Date 9-25-07**PLAN REVIEW REVISION SUBMITTAL**

Project name RESIDENCES @ TROLLEY PARK

REVISION TO SWITCHBOARD SERIES PANEL RATING**----- THIS SPACE FOR OFFICE USE ONLY -----****Reviews****Review time**

We are in receipt of the plan review comments by the City of Aurora Building Department. Below are the comment numbers followed by our responses. Please forward this information to the appropriate parties for review.

1 A2.0 GARAGE LEVEL FLOOR PLAN
SCALE: 1/8"=1'-0"

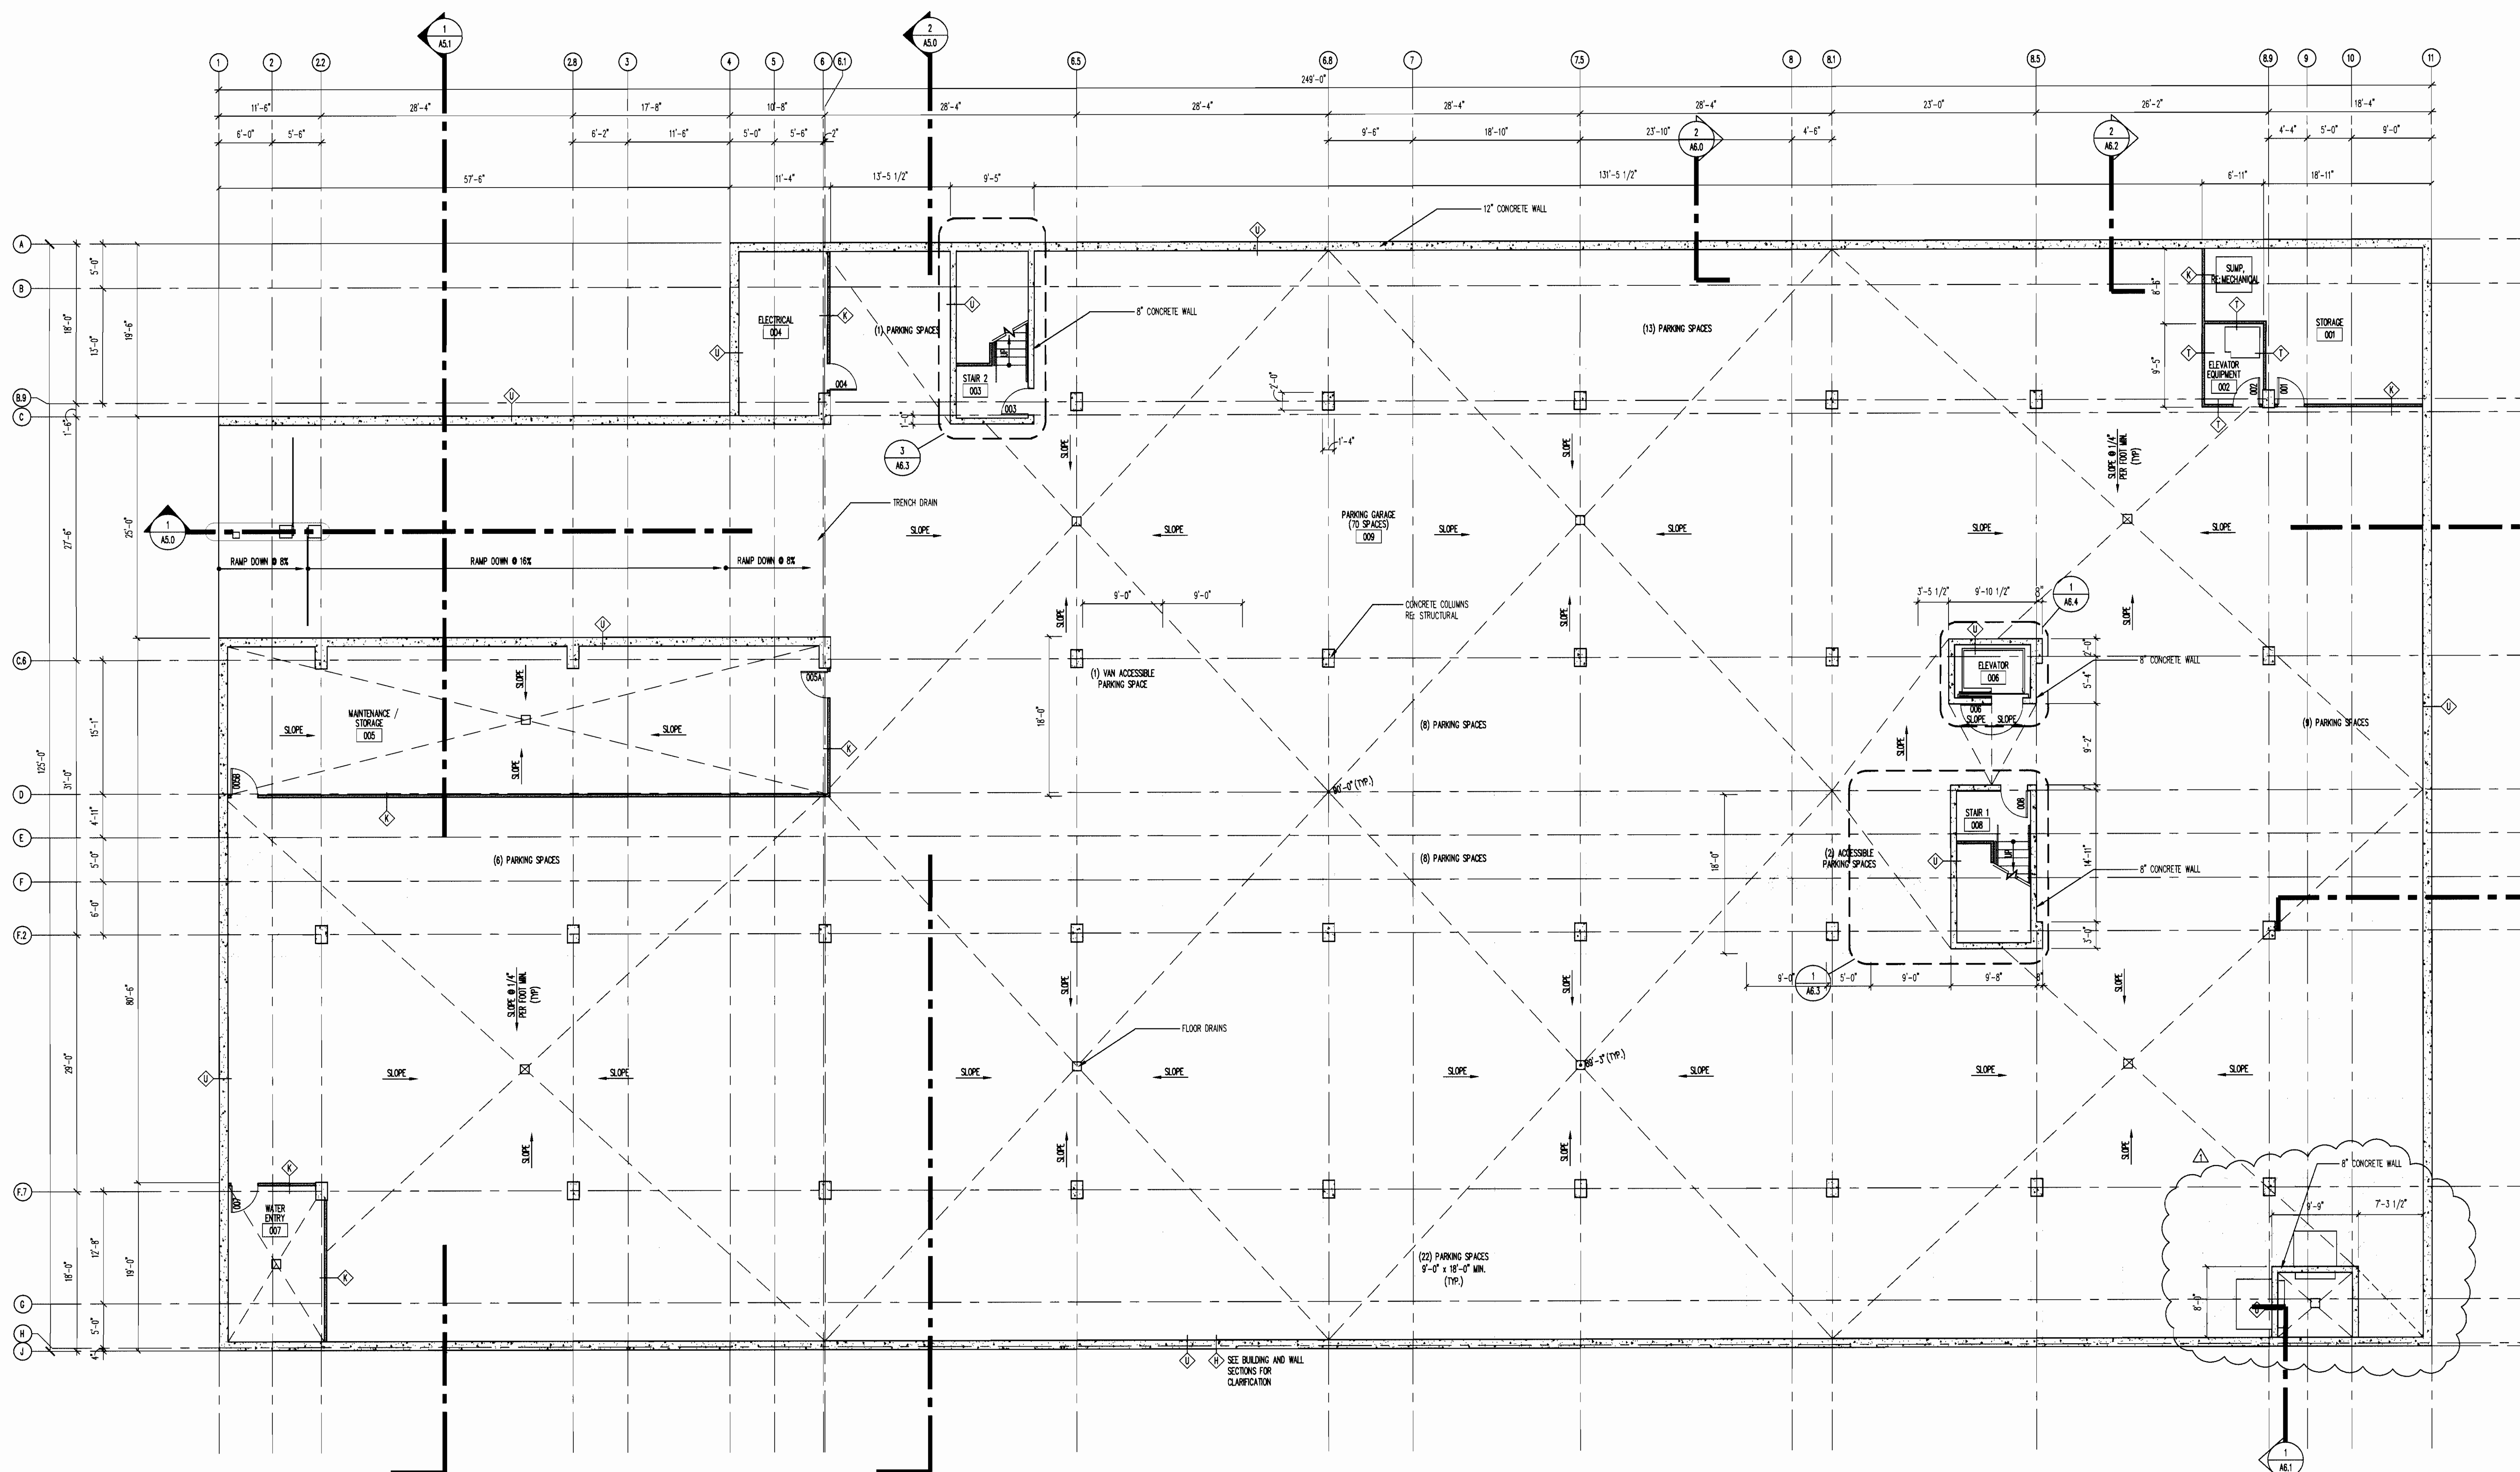
- A-7 Sheet A2.0 indicate that there is an opening in the horizontal assembly for the venting of the garage. This opening is adjacent to the residence portion above and would not be afforded proper protection. The walls below shall be of 3-hour with an appropriate fire damper. IBC 711.4 and 716.6.1.

Response – The walls have been revised to Wall Type 'U' 8" cast in place concrete.

1 1ST LEVEL FLOOR PLAN
SCALE: 1/8"=1'-0"

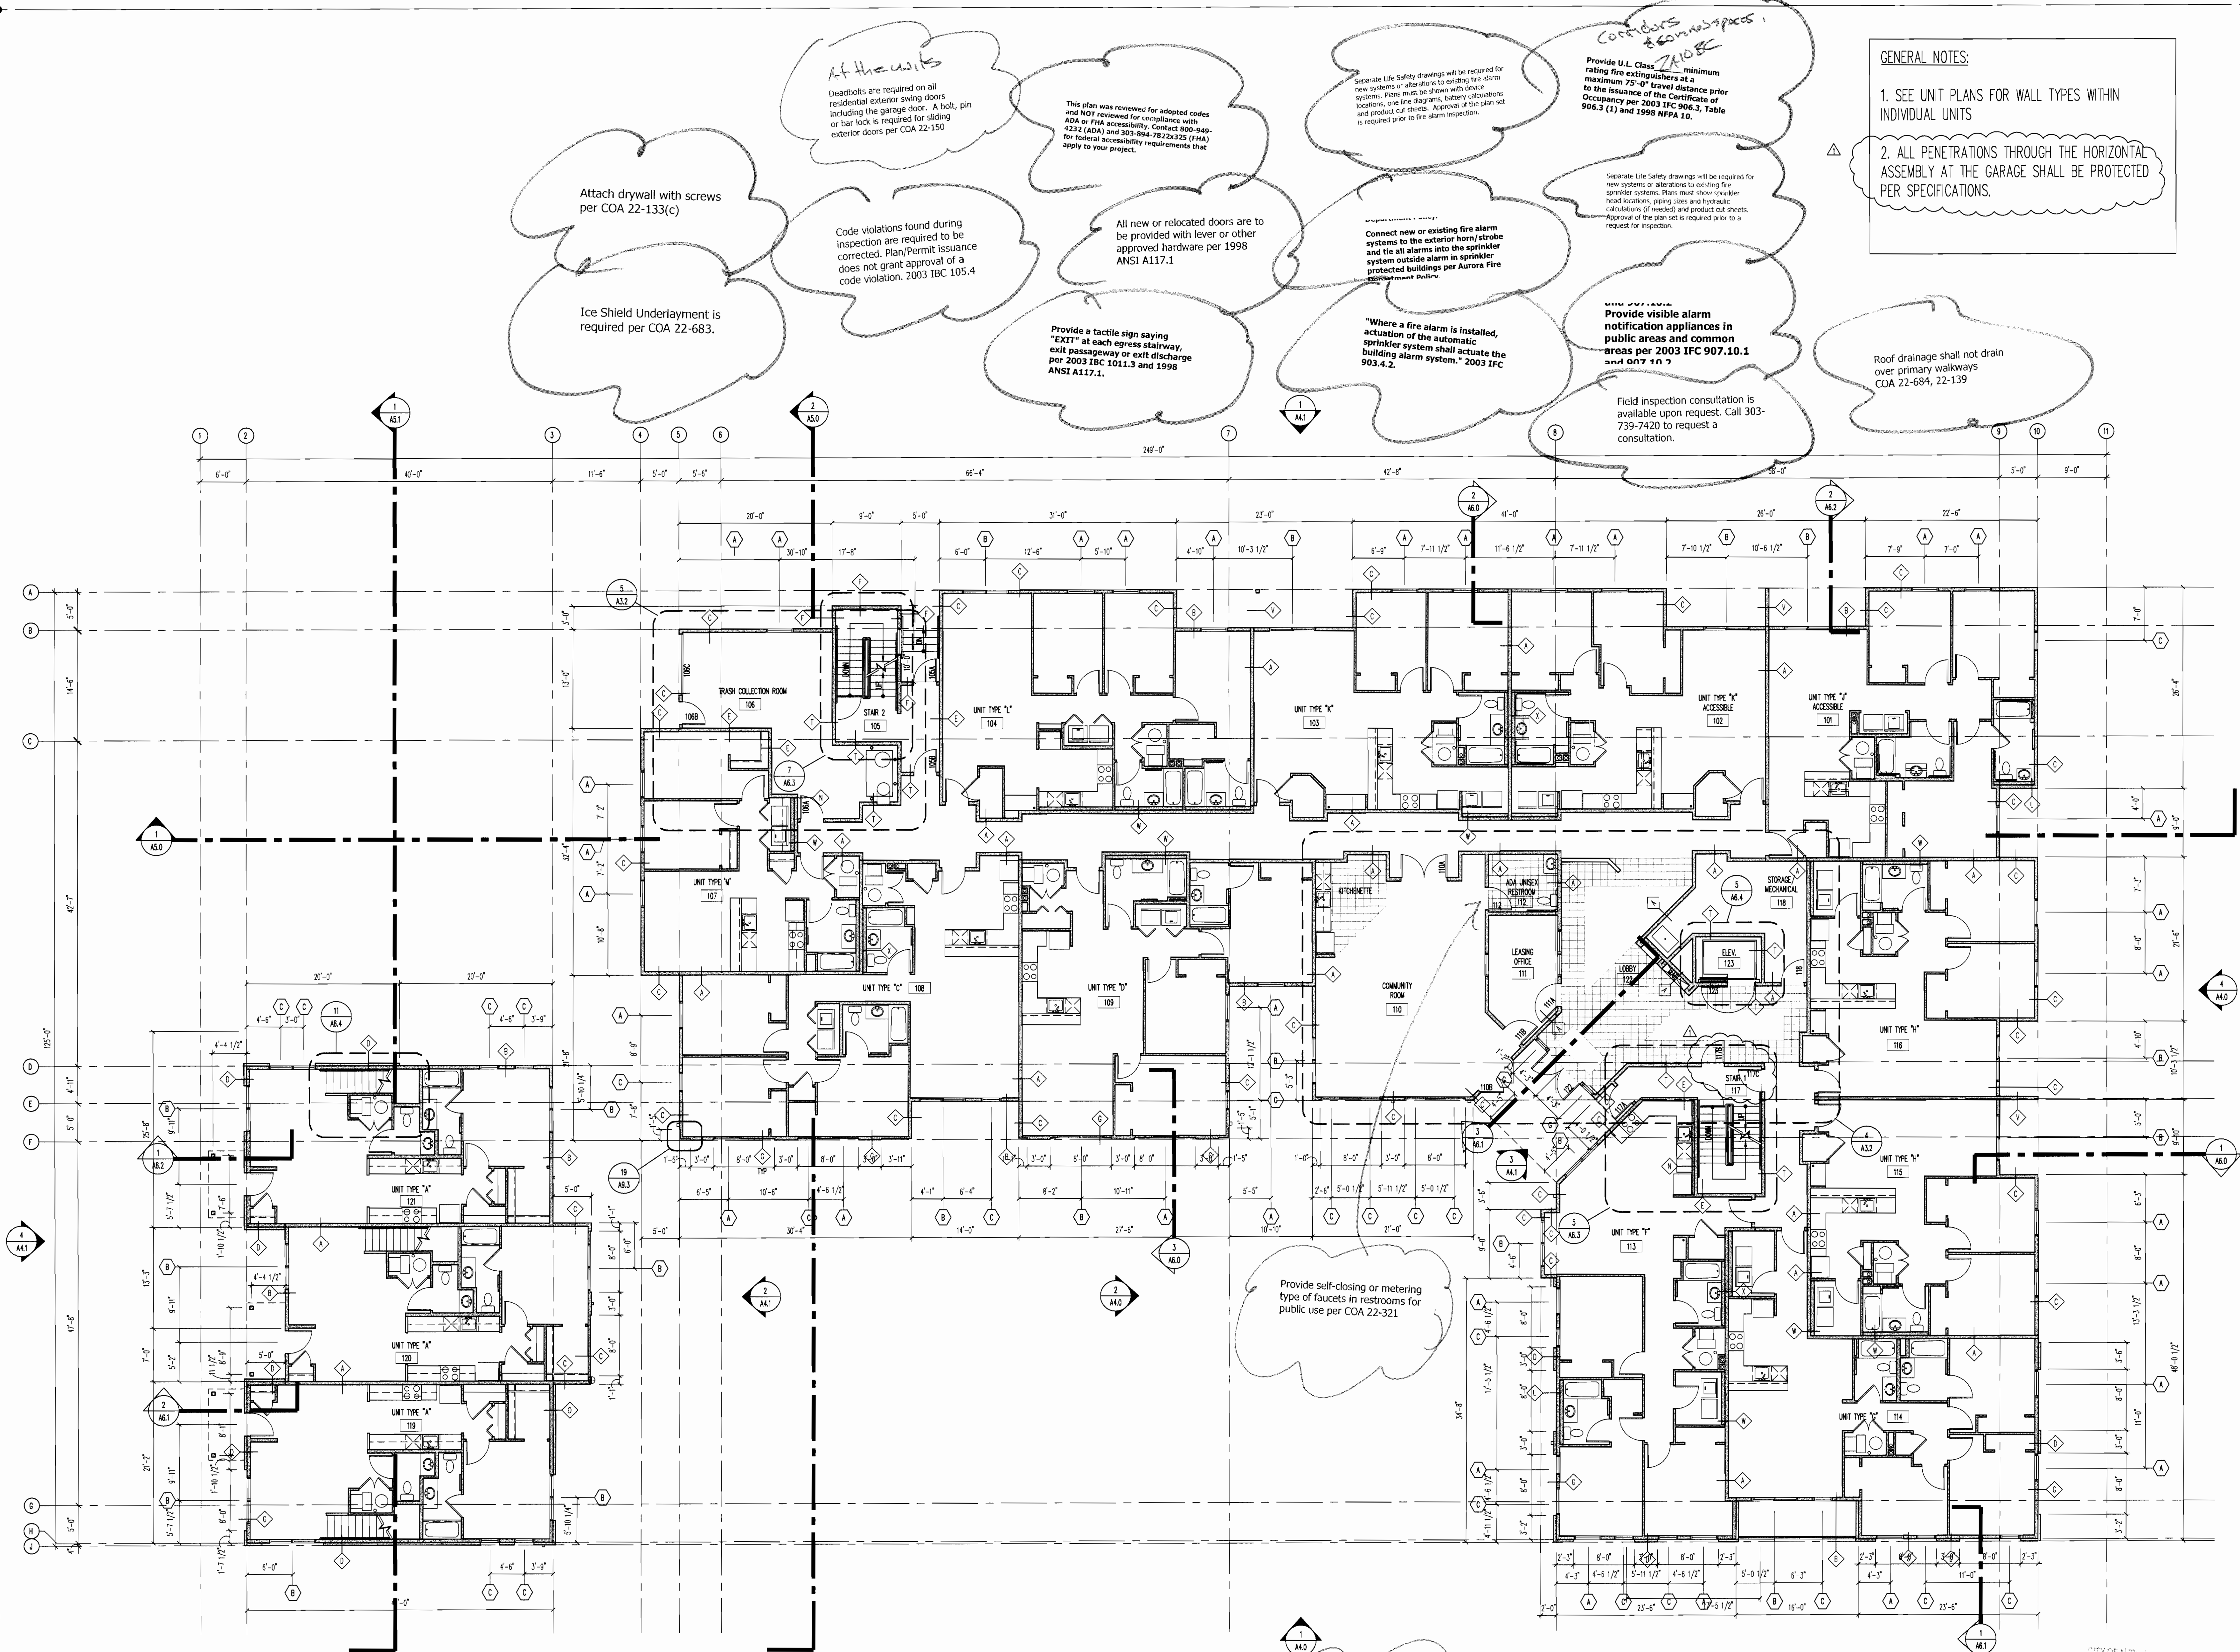
- A-10 Sheets A2.1 and A2.2 indicate that there are windows between units 120 and 121. I assume this was in error, please revise.

- A-11 Sheet A2.1 the refuse collection room is a continuation of the refuse chute above. The opening to the access corridor at the first floor from the compactor will not be allowed. IBC 707.13.1 and 707.13.3.

Response – This is a result of the drafting program and has been revised to not show the windows.

Response – The current solution does not show a compactor. The door has been rated 90 minutes.

DRAWING NO.:
M2.1

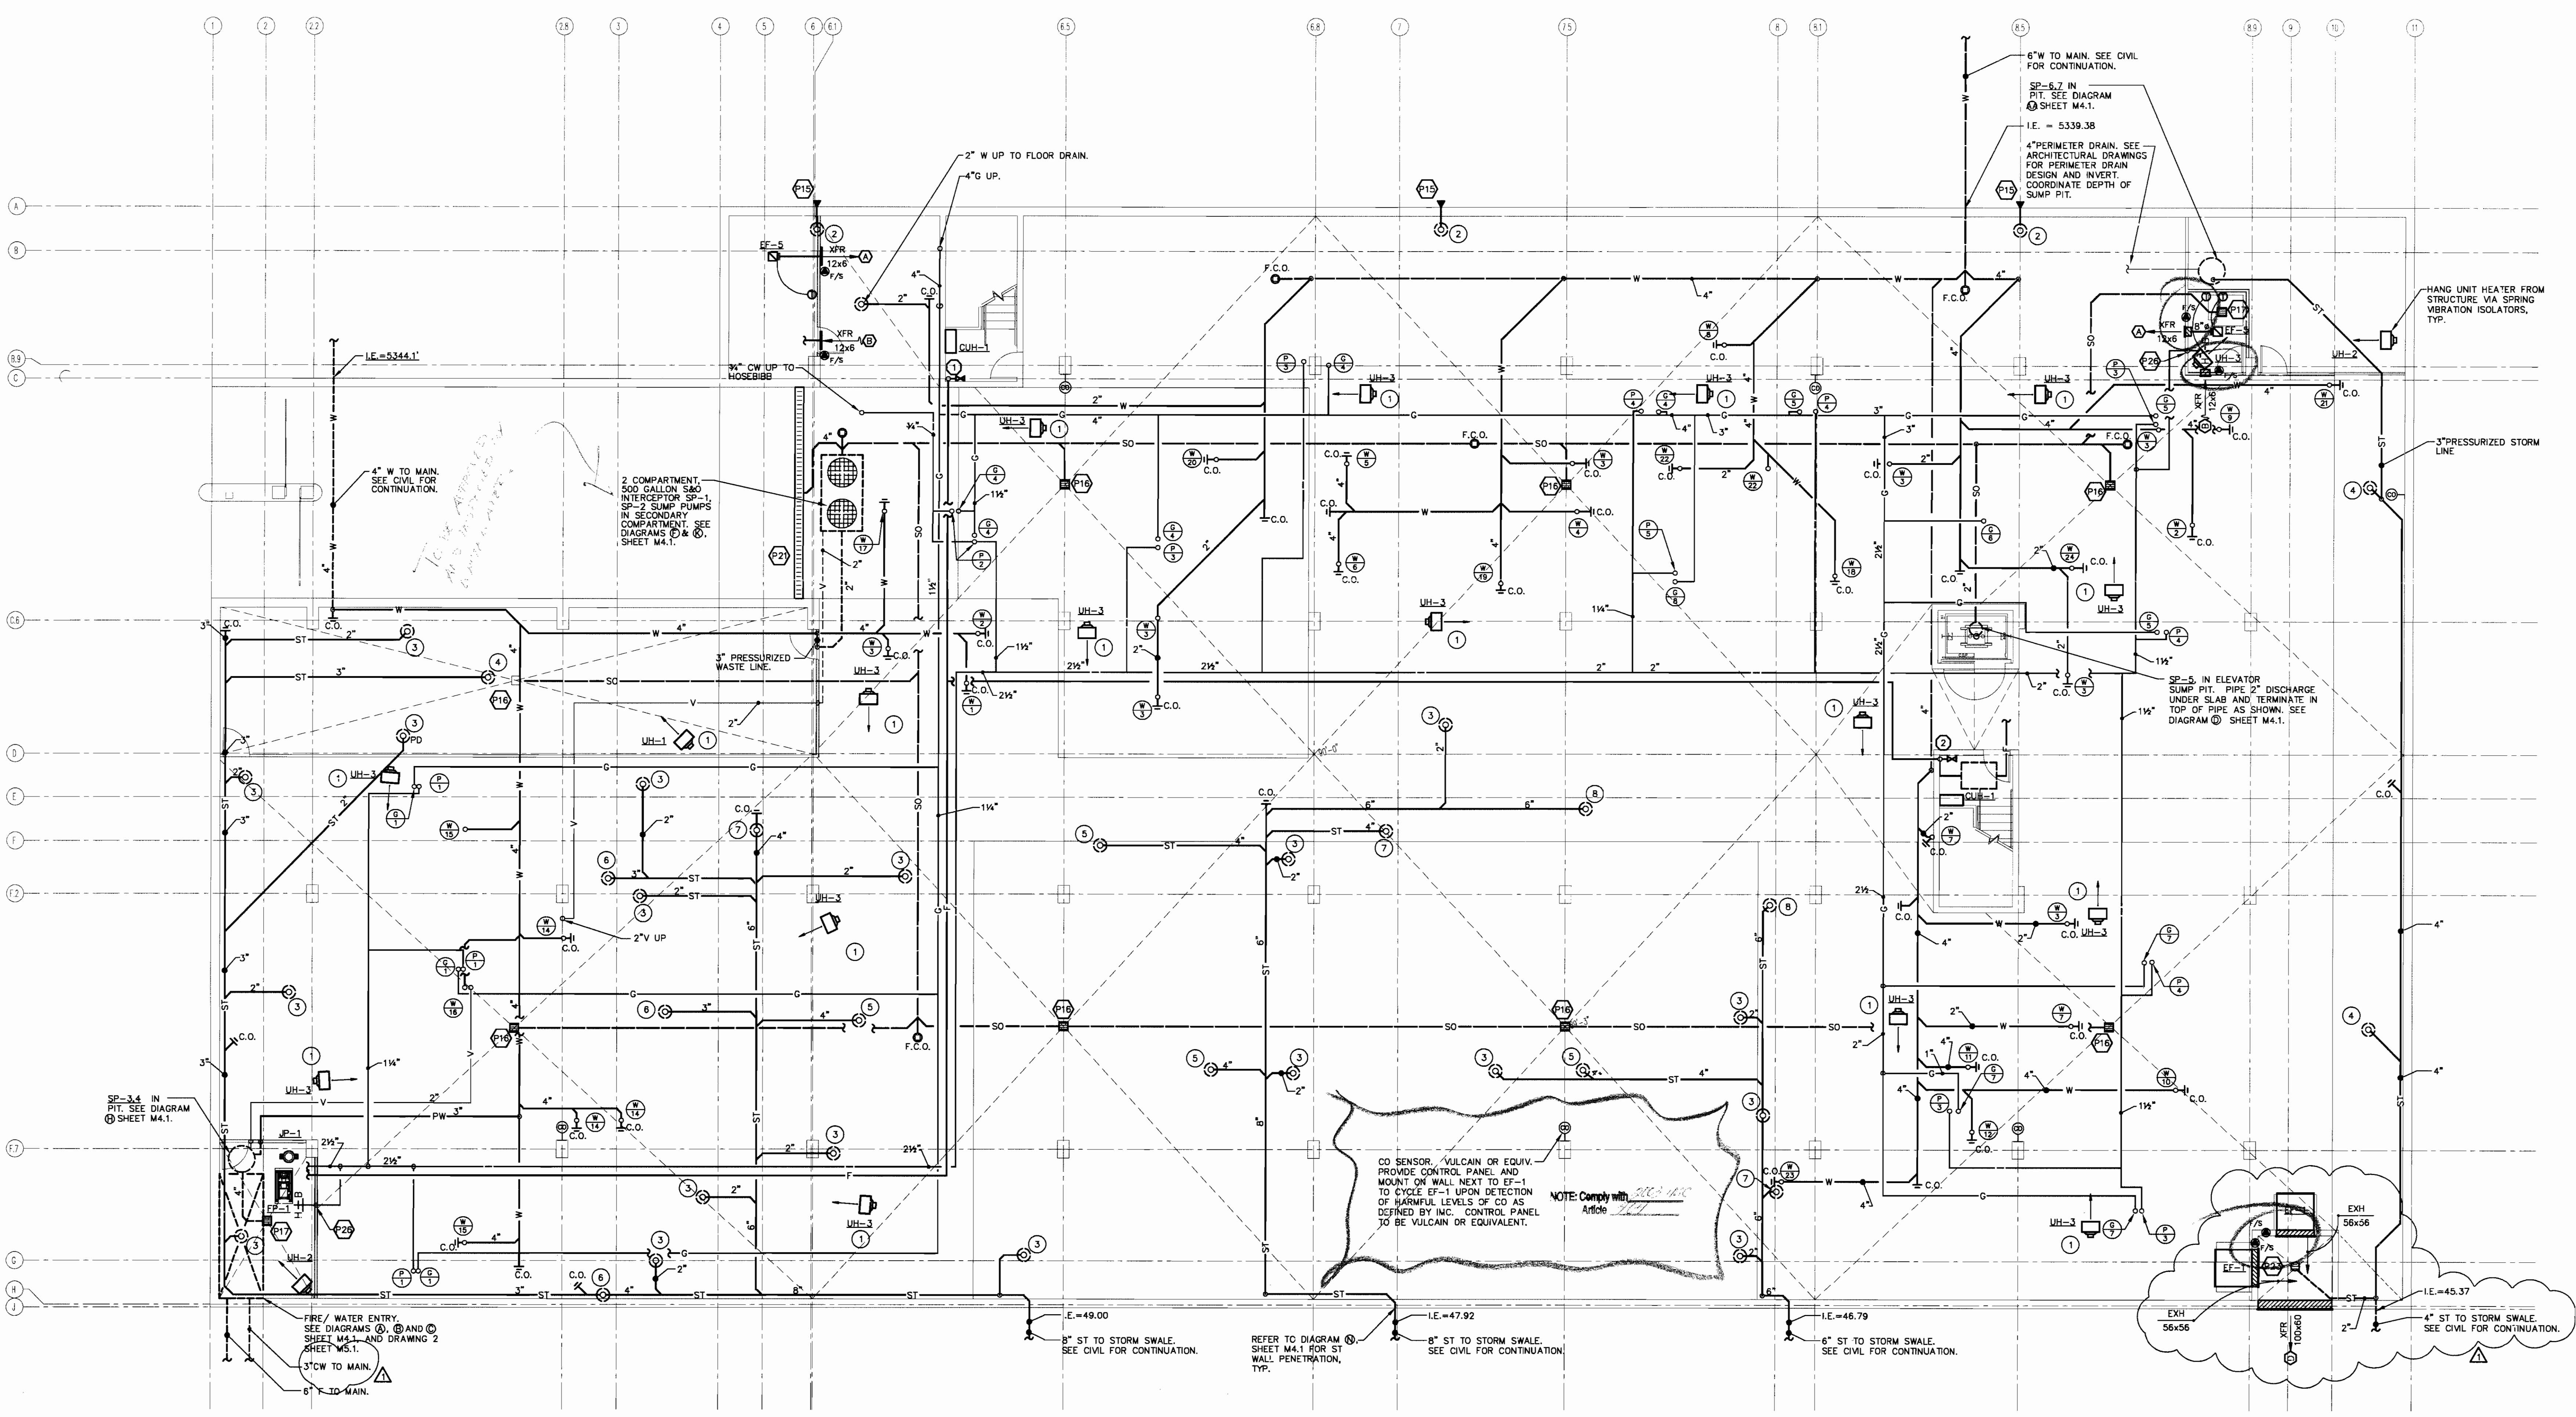
P-1 Sheet M2.1 Provide a secondary (Emergency) roof drains for the garden area between grid lines 4-8 and F-J, as required by 2003 IPC 1107.

Response - The garage exhaust is revised to blow out the east garage wall. See revised sheet M2.1 and revised architectural drawings.
